**DOCUMENT 00 90 00
ADDENDUM**

ADDENDUM NO. [2] M Date: April 4, 2018

**RE: WITC – SUPERIOR CAMPUS
SUPERIOR INTERIOR AND EXTERIOR MAINTENANCE & REMODEL
600 N 21ST STREET
SUPERIOR, WI 54880
HSR PROJECT NO. 17063-1**

FROM: HSR Associates, Inc
100 Milwaukee Street
La Crosse, WI 54603
(608) 784-1830

8 CASEWORK ELEVATION
1/4" = 1'-0"

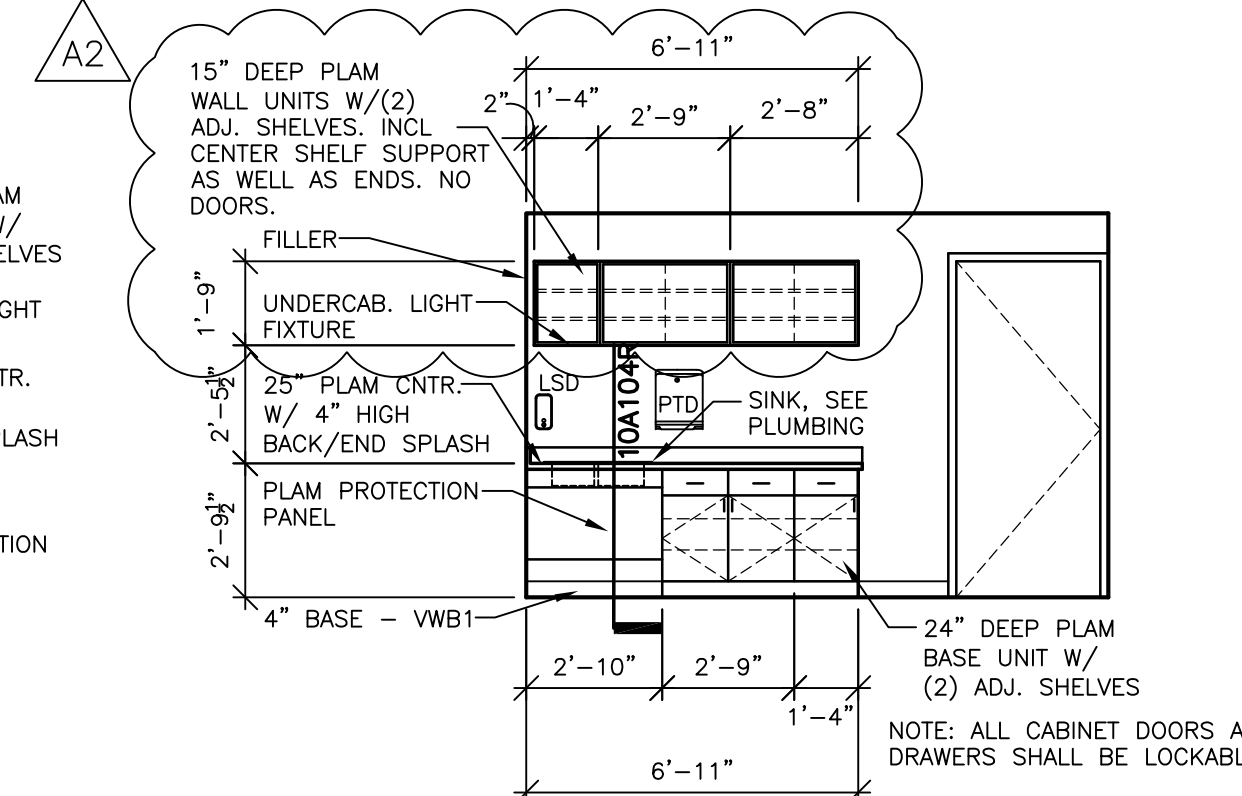
- a. Revisions clouded on Drawing.
11. Sheet A104R1 PHARMACY TECH PLANS AND DETAILS 30 x 42 attached hereto
 - a. Revisions clouded on Drawing.
12. Sheet A310R PLAZA SECTION, ELEVATIONS AND DETAILS 30 x 42 attached hereto

ALL DETAILS HAVE BEEN REVISED.

M111R

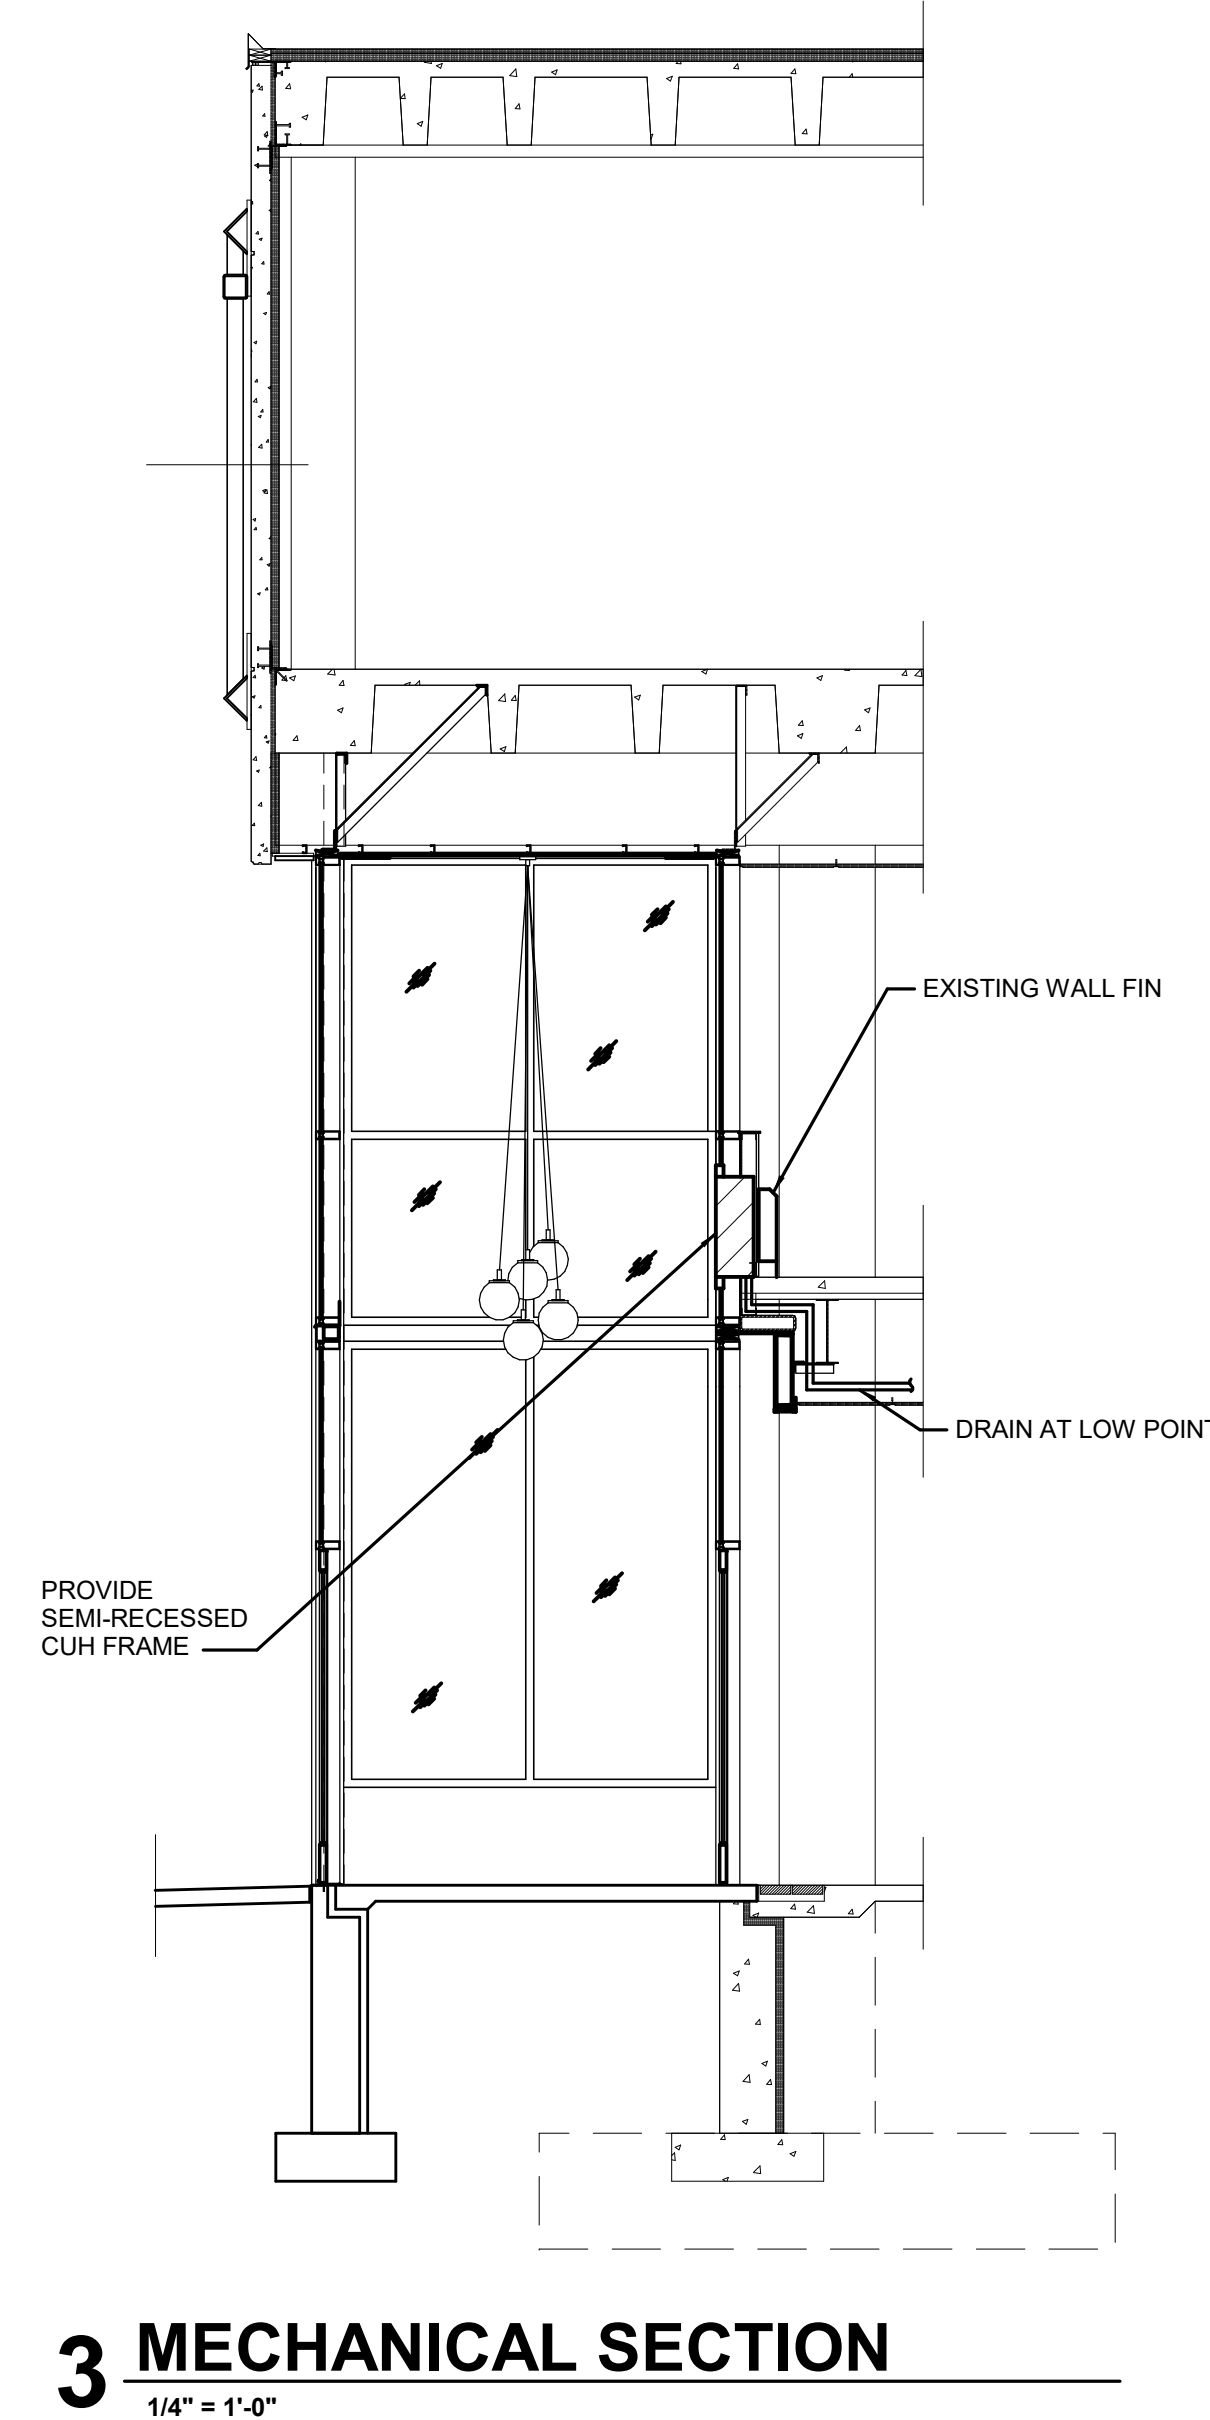
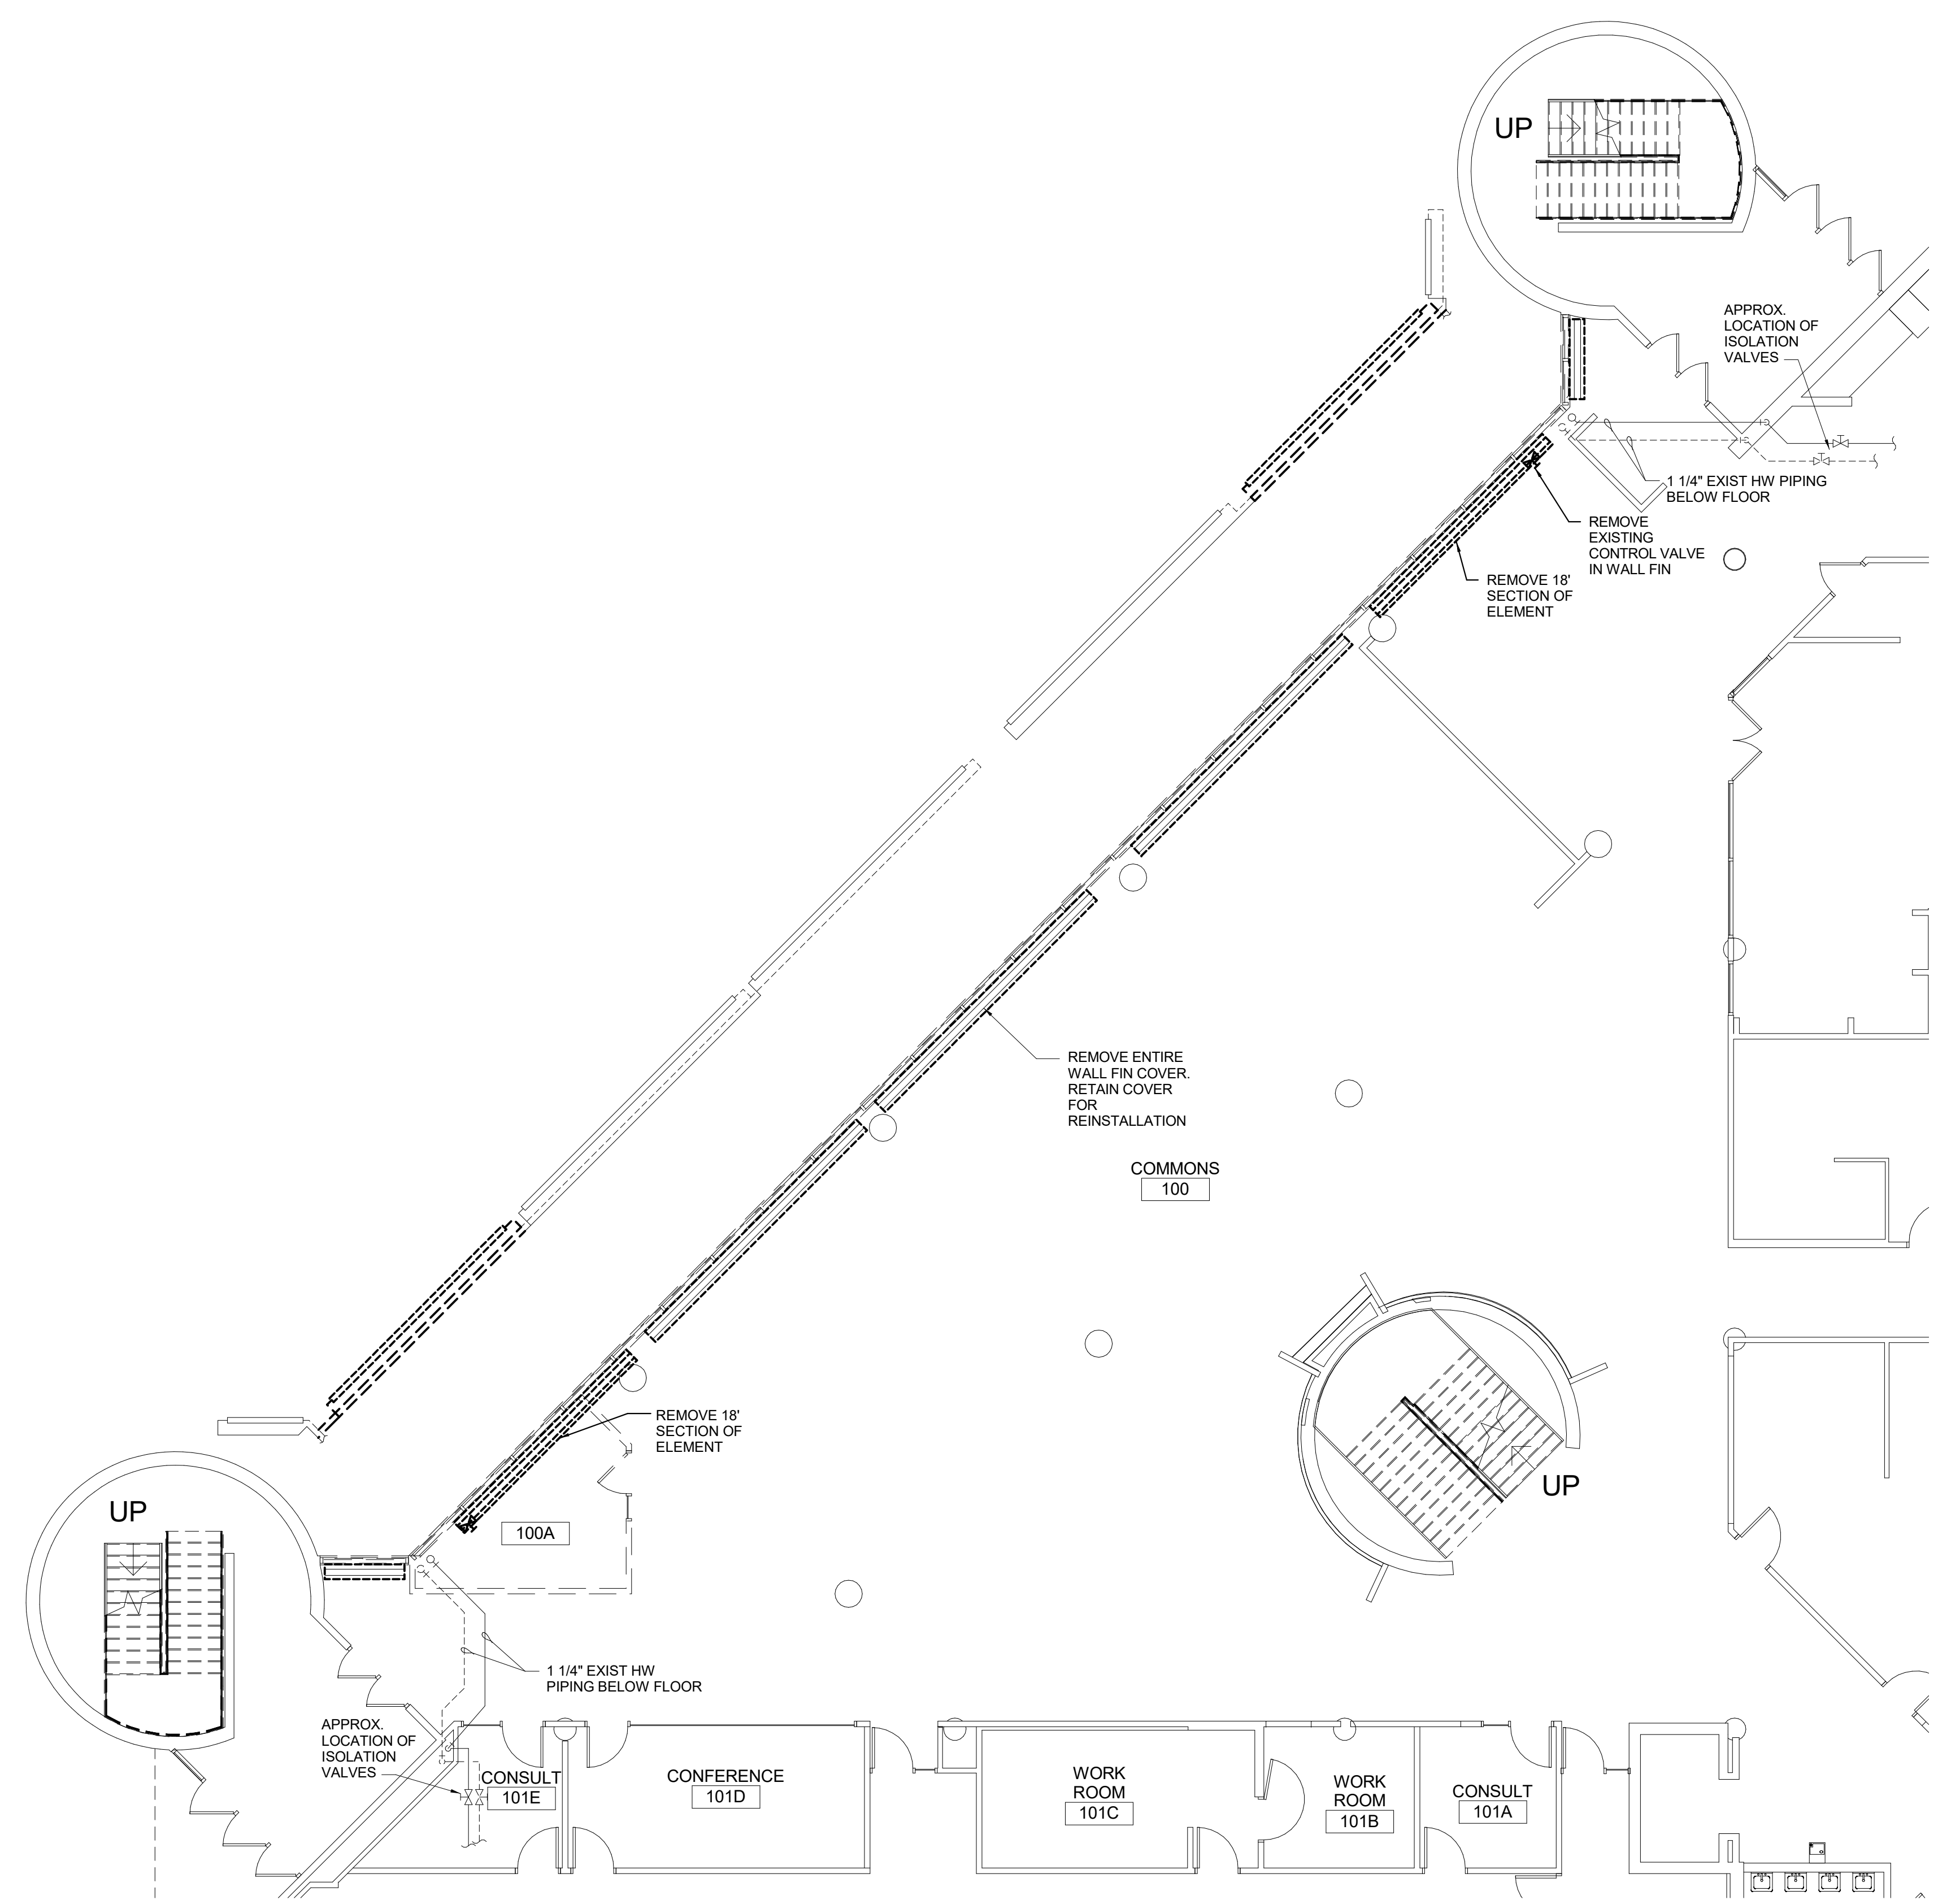
- a. Revisions clouded on Drawing.
17. Sheet S201R SECTIONS AND DETAILS 30 x 42 attached hereto
 - a. Revisions clouded on Drawing.
18. Sheet M111R MECHANICAL NEW & DEMOLITION PLANS – 1st FLOOR 30 x 42 attached hereto.

- a. Revisions clouded on Drawing.
 - b. Thermostat location for AC-1 clarified.
 - c. Pipe route for AC-1 refrigerant piping revised.
 - d. Clarification of cut and patch responsibilities for saw cutting, core drilling and chase removal.
